LOCAL HISTORIC DISTRICT: Dilworth

PROPERTY ADDRESS: 315 East Boulevard

SUMMARY OF REQUEST: New construction

Charlotte Historic District Commission Case 2017-393
HISTORIC DISTRICT: DILWORTH
NEW CONSTRUCTION

HDC-15

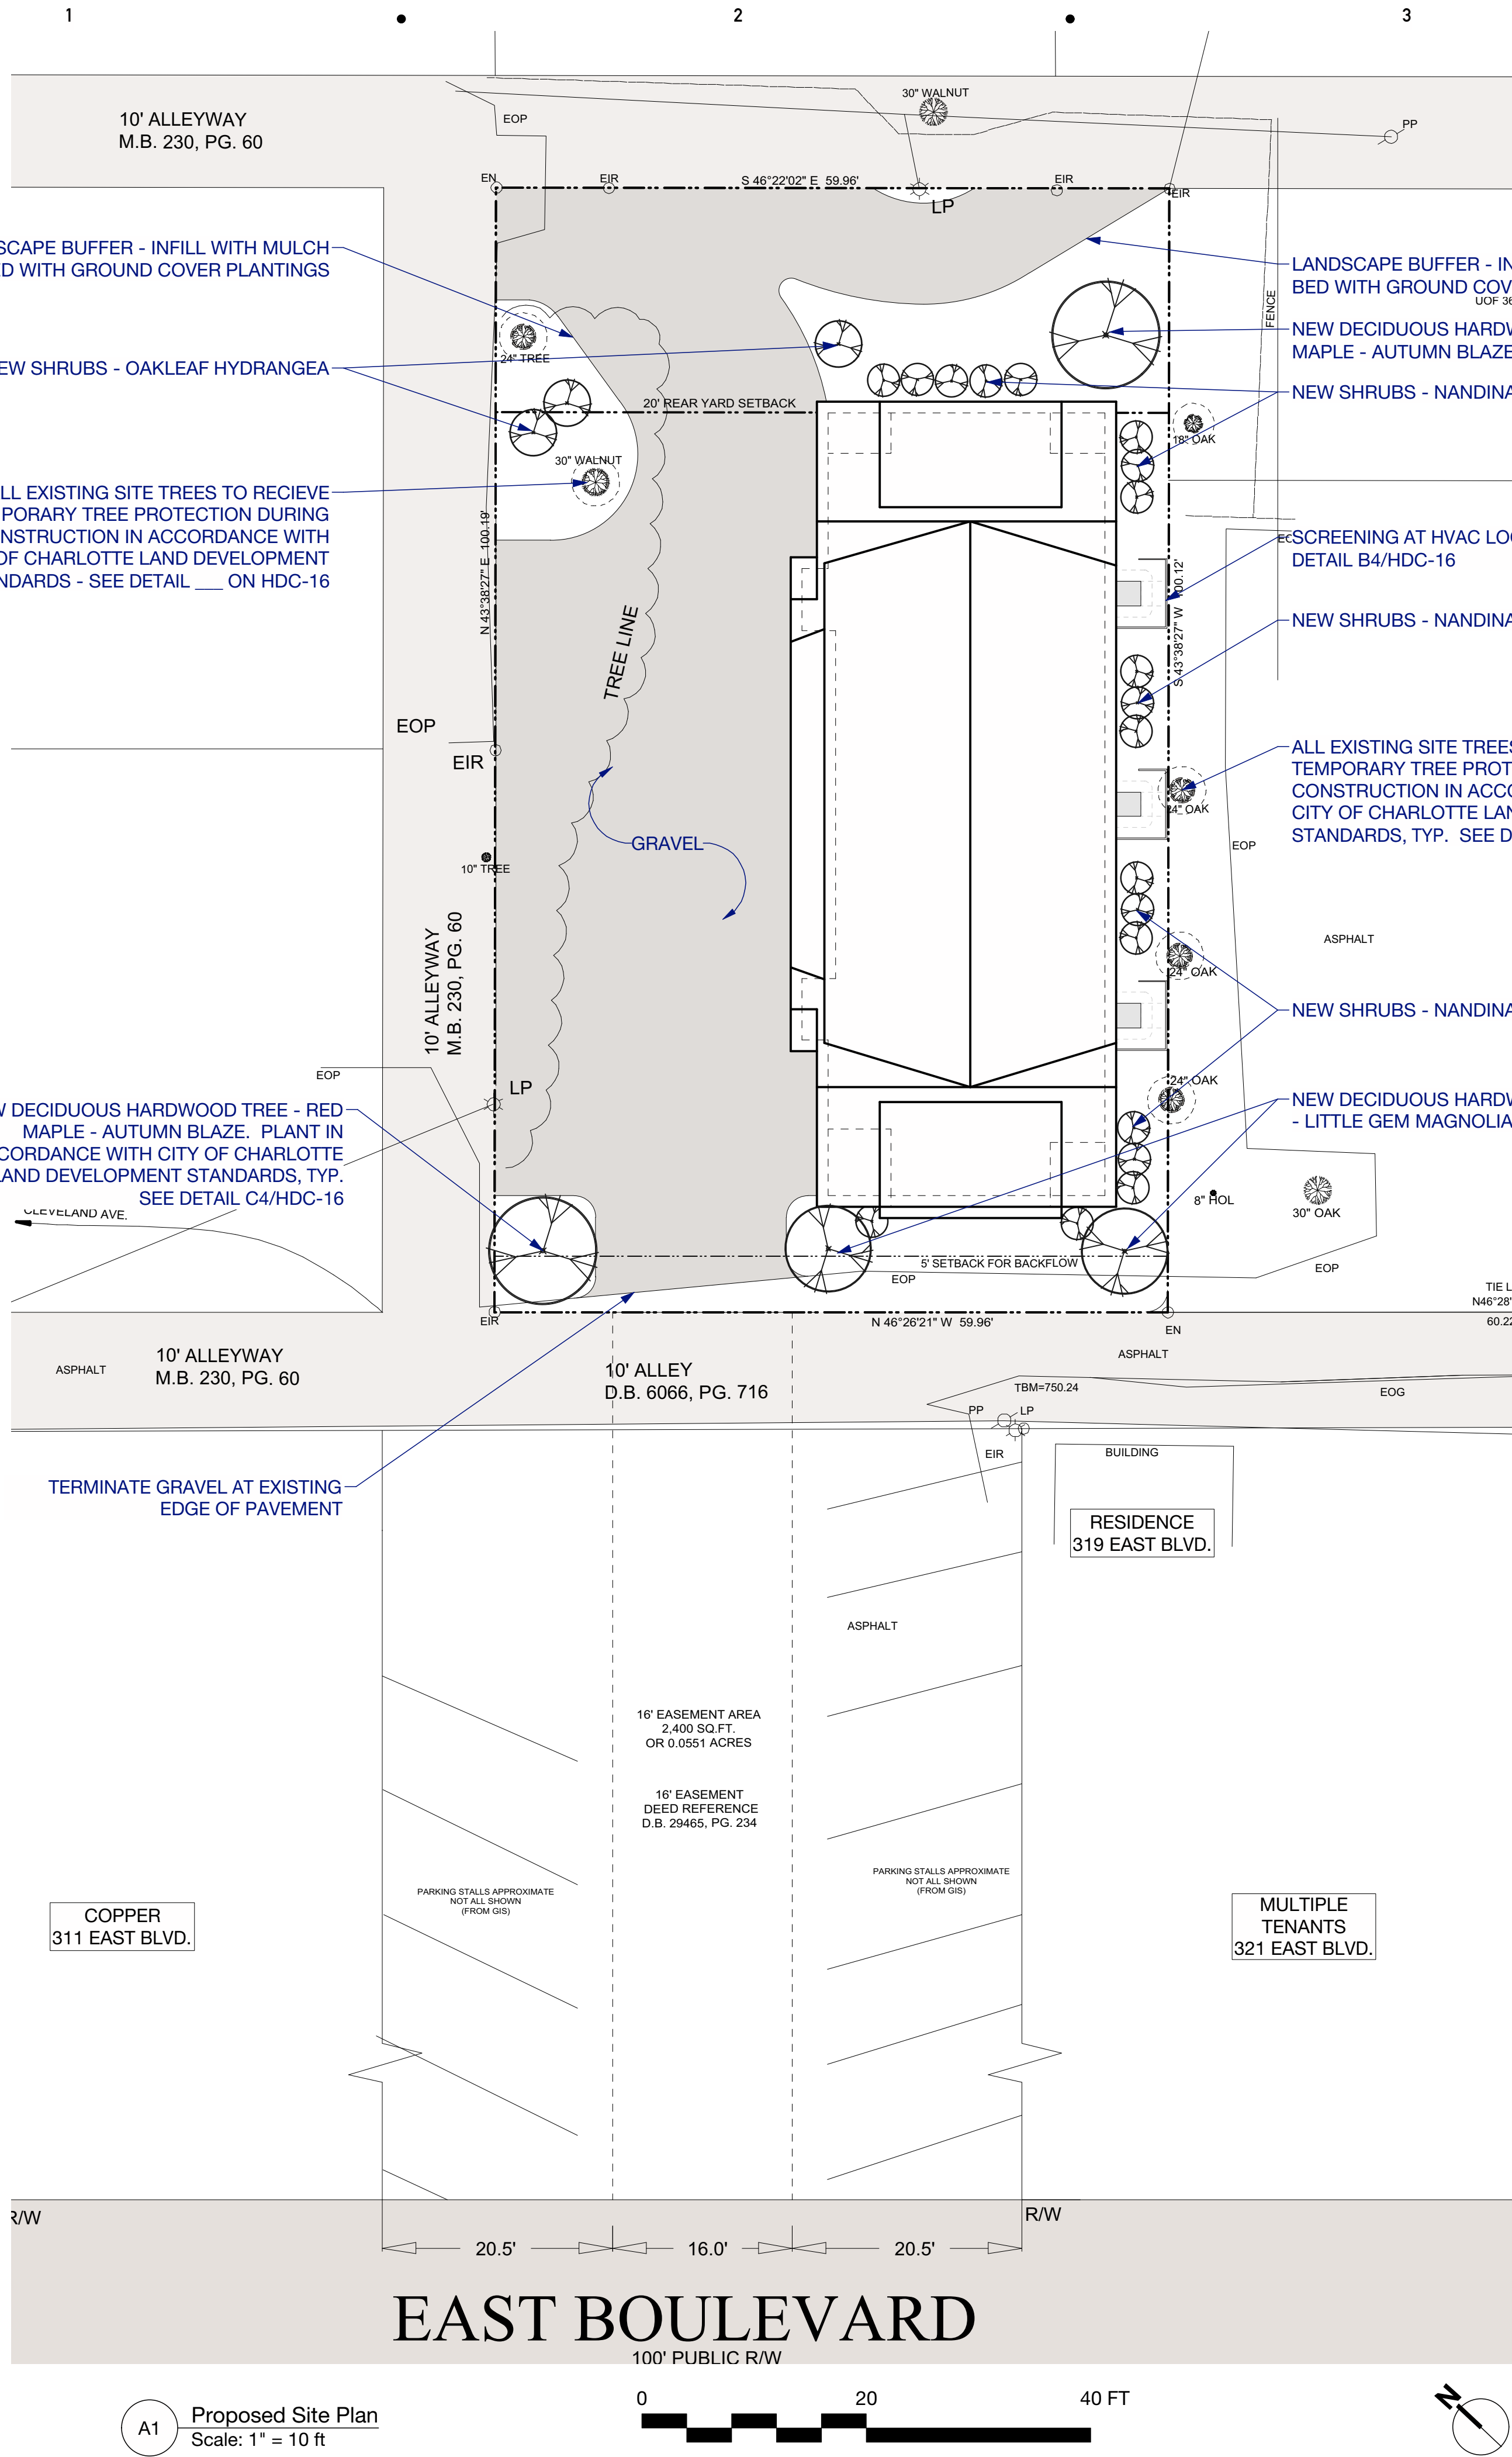
The application was continued from July for the following: 1) Provide an additional site plan that shows a 20' easement abutting the parking lot, revised fence and gate location, 2) landscaping plan, 3) tree protection plan, 4) Provide screening for AC units, 5) Eliminate the window aprons, 6) Consider design options for the elevation facing 315 East Boulevard.

- Provide an additional site plan that shows a 20' easement abutting the parking lot, revised fence and gate location
- Landscaping plan
- Tree protection plan
- Provide screening for AC units
- Eliminate the window aprons
- Consider design options for the elevation facing 315 East Boulevard

1. Sheet #HDC-15 – The additional 10' easement has been included.
2. Sheet #HDC-15 – AC screening is included
3. Sheet #HDC-15/16 – Landscaping and tree protection plan is included
4. Sheet #HDC-20 – East Boulevard elevation has been revised
5. Sheet #HDC-15 – Window trim has been revised
